SUBJECT: COMANCHE PEAK STEAM ELECTRIC STATION (CPSES)
DOCKET NOS. 50-445 and 50-446
NRC REQUEST FOR ADDITIONAL INFORMATION CONCERNING
MSIV BYPASS VALVES

RESPONSES TO NRC REQUEST
FOR ADDITIONAL INFORMATION

RESPONSES TO COMMENTS ON TECHNICAL SPECIFICATIONS

RESPONSES TO COMMENTS ON FSAR AMENDMENT 56

FIGURE 6.2.4-1 Sh. 5 of 10

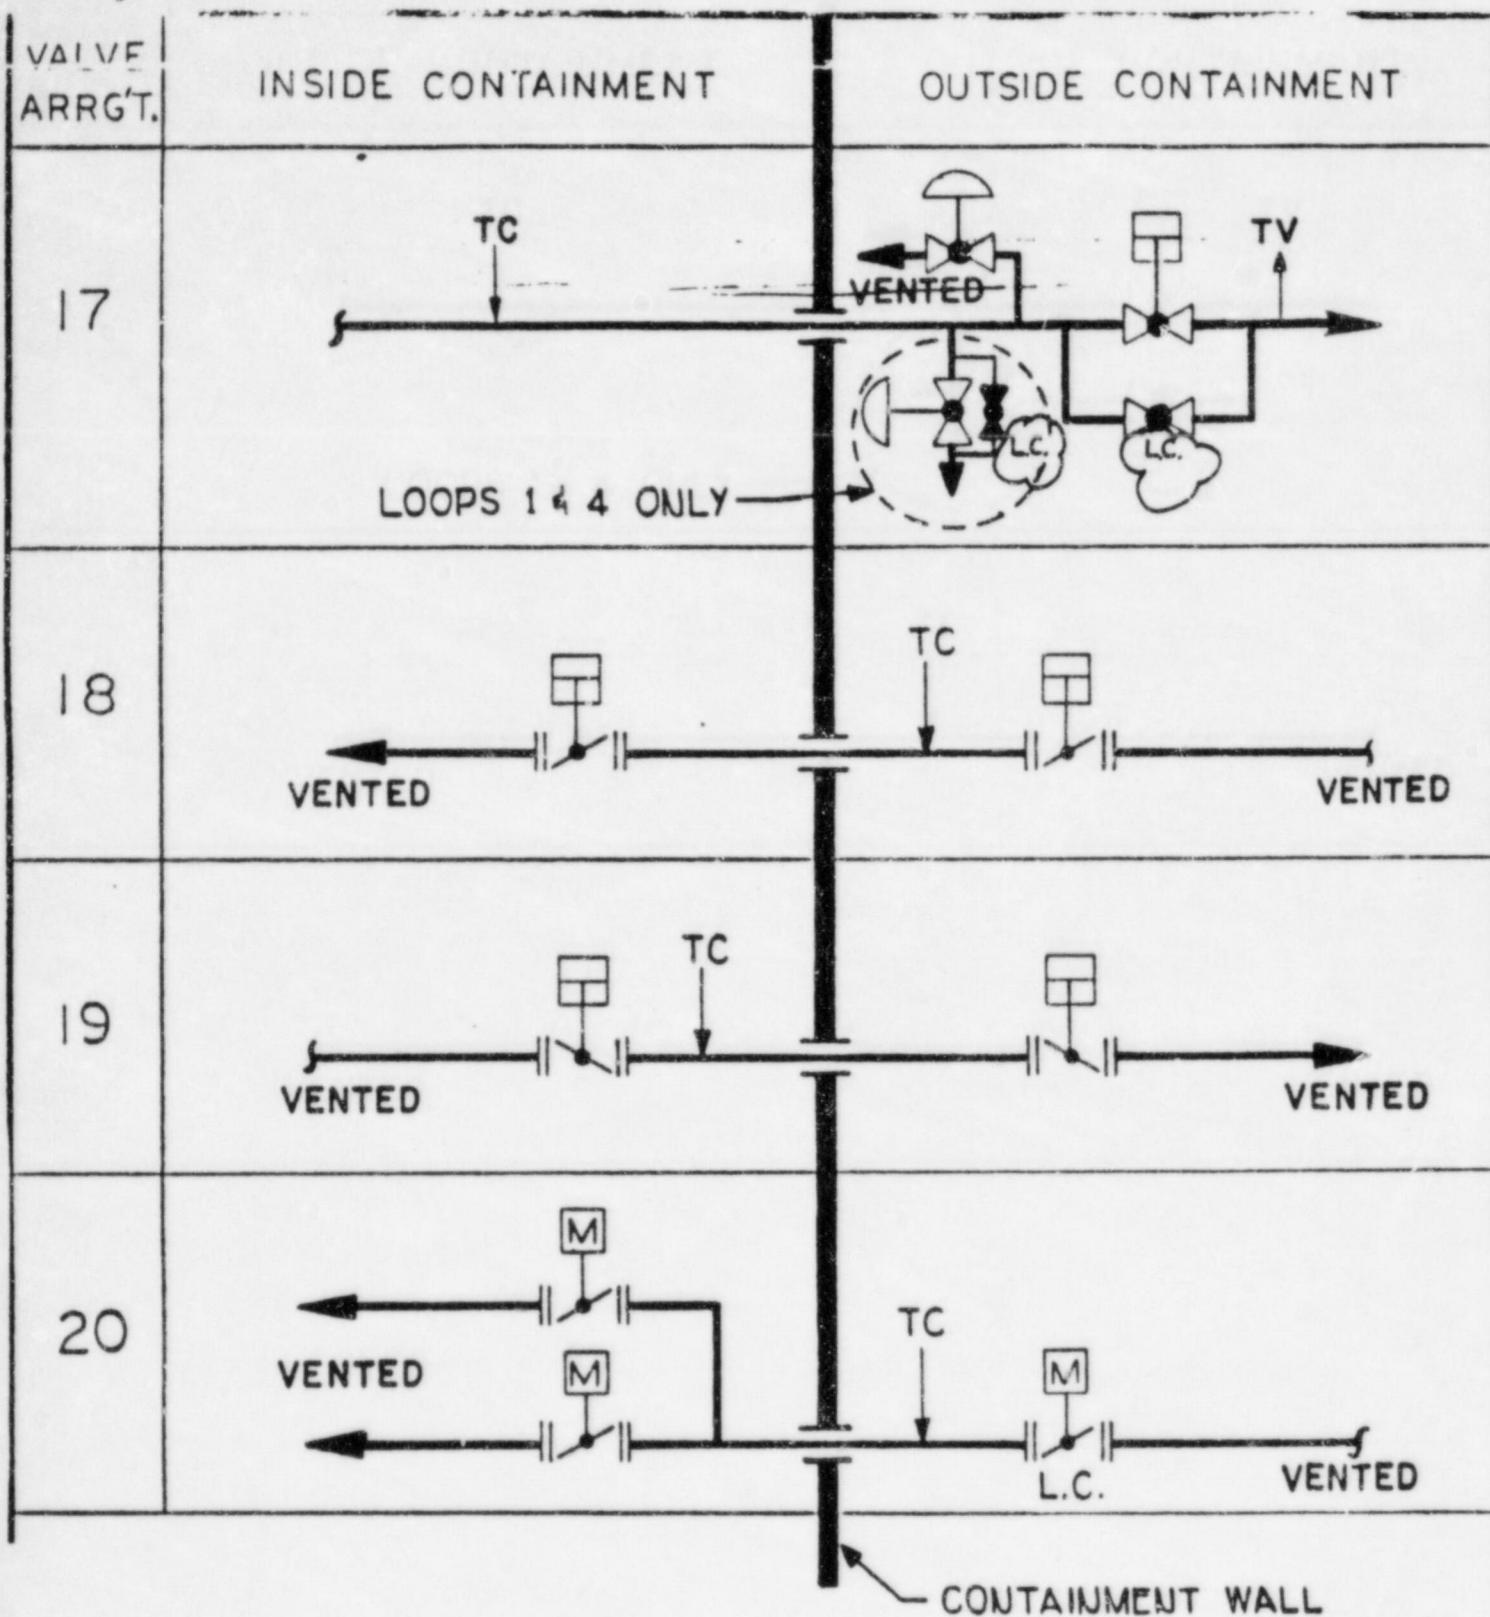
5. Comment Figure 6.2.4-1; Sheet 5 of 10; Valve arrangement 17; Outside Containment; should indicate locked closed.

Response See revised Figure 6.2.4-1, sheet 5 of 10.
